## PIC18F66K80 Family Silicon Errata and Data Sheet Clarification

The PIC18F66K80 family devices that you have received conform functionally to the current Device Data Sheet (DS39977F), except for the anomalies described in this document.

## Data Sheet Clarifications

**FIGURE 11-2: USING THE OPEN-DRAIN OUTPUT (USARTx SHOWN AS EXAMPLE)**

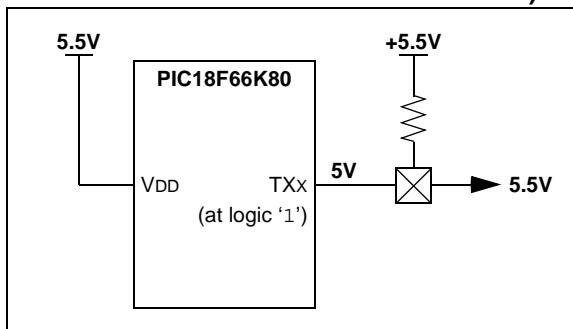
### 4.2 Open-Drain Outputs Diagram

Figure 11-2: Using the Open-Drain Output (Usart Shown as Example) on page 173 should be as follows:

Page 173 Section 11.1.3 'Open-Drain Outputs' will be revised to:

The output pins for several peripherals are also equipped with a configurable, open-drain output option. **This allows the peripherals to communicate with external pull-up voltage.**

**When the open-drain option is required, the output pin must also be tied through an external pull-up resistor provided by the user.**
